**DIVISION OF RATEPAYER ADVOCATES  
CALIFORNIA PUBLIC UTILITIES COMMISSION**

**Report on the  
Pipeline Safety Enhancement Plan of  
Pacific Gas and Electric Company**

Pipeline Modernization Plan

**R.11-02-019**

1 **Figure 13 – Results of PG&E QRA analysis for entire PSEP**

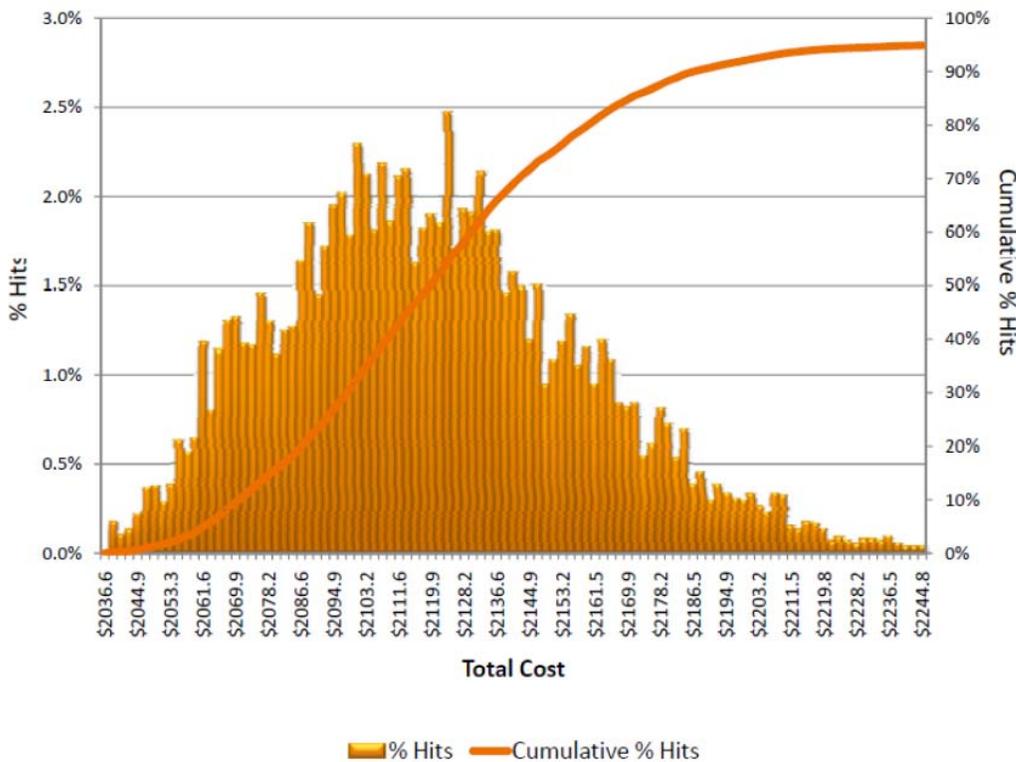
PG&E’s QRA analysis is best summarized by the “Cumulative % Hits”  
versus “Total Cost” relationship shown on Figure 7-5 of PG&E’s Testimony:<sup>188</sup>

<sup>188</sup> Figure 7-5 in PG&E’s Testimony is incorrect. See PG&E’s response to DRA data request DRA\_041-07. A corrected figure was provided in the January 20, 2012 Errata filing, p. 7-42.

1 Figure 7-5 would show that there would be a probability of greater than zero (P0)  
2 that actual costs will be less than the 2,036.6 million PG&E shows in Figure 7-5.  
3 If PG&E were to use the AACE I Classification Range (-30% to +50%) shown in  
4 Table 7-6 for Class 4 estimate, it can be argued that the P0 values should be even  
5 *less* than the baseline cost of \$1,803.4 million. Given that DRA's analysis shows  
6 PG&E's baseline cost estimate to be higher than industry averages, the QRA  
7 should show a significant probability that actual costs could be lower than the  
8 baseline estimate. The histogram shown in Figure 7.5 does not show distribution  
9 of outcomes for actual costs on either side of the base estimate as the AACEI  
10 range for a Class 4 estimate would indicate. At a minimum, the QRA should show  
11 a significant probability that actual costs could be less than PG&E's current

1 **Figure 14 - Results of PG&E QRA analysis for the replacement portion PSEP**  
 2 **Pipeline Plan pipeline replacement program**

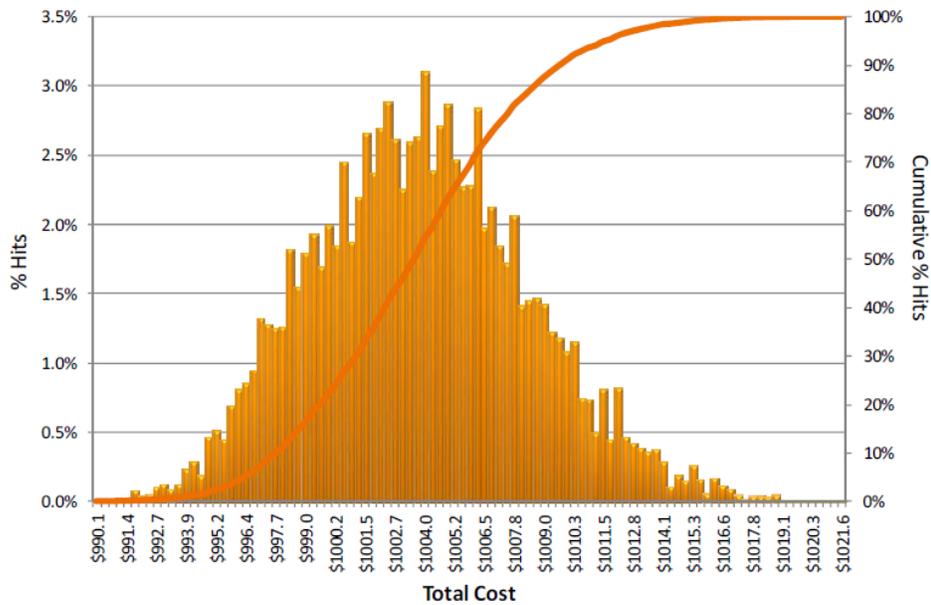
3  
 4 This graph makes it look as though there is a wide range of outcomes for actual  
 5 costs. However, recall that the baseline estimate for pipeline capital project,  
 6 primarily pipeline replacement, is \$928.1 million. DRA first reformatted the  
 7 above data to show the Monte Carlo results for pipeline capital projects the 20%  
 8 contingency used by PG&E, and PG&E's P90 value:<sup>190</sup>  
 9  
 10

1 **Figure 15 – PSEP Contingency request for pipeline replacement compared to**  
 2 **PG&E QRA results<sup>191</sup>**

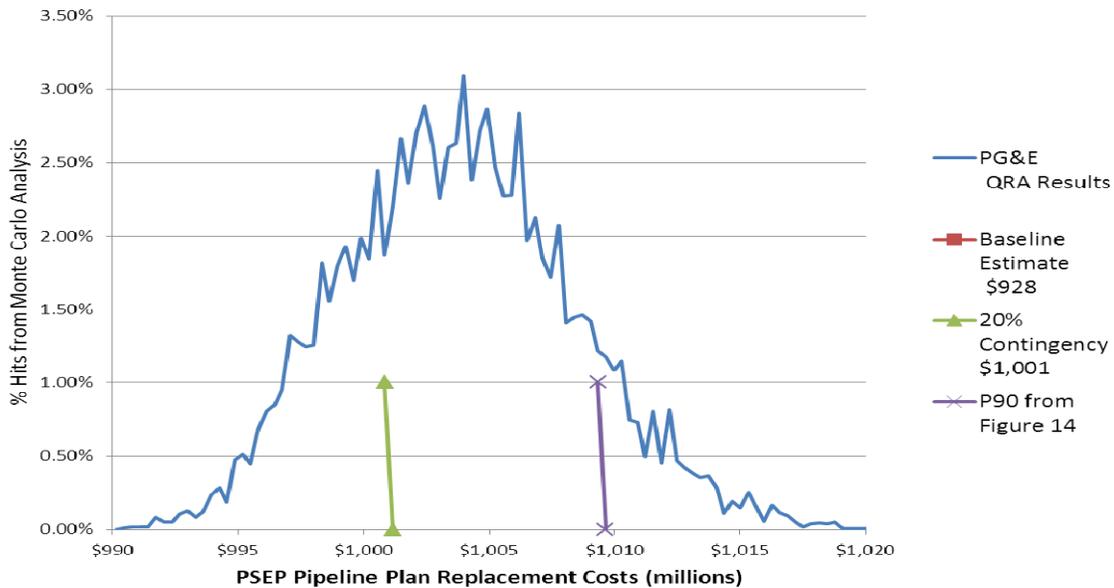
5 Figure 15 illustrates that PG&E’s QRA provides outcomes roughly  
 6 centered on the 20% value chosen by PG&E, but skewed to the right (greater  
 7 probability of higher cost). This figure also illustrates the discrepancy mentioned  
 8 in footnote XXX of this exhibit, since PG&E’s 20% contingency is supposed to be  
 9 a P90 value. It is clear from this figure that the 20% contingency is not a P90  
 10 value.
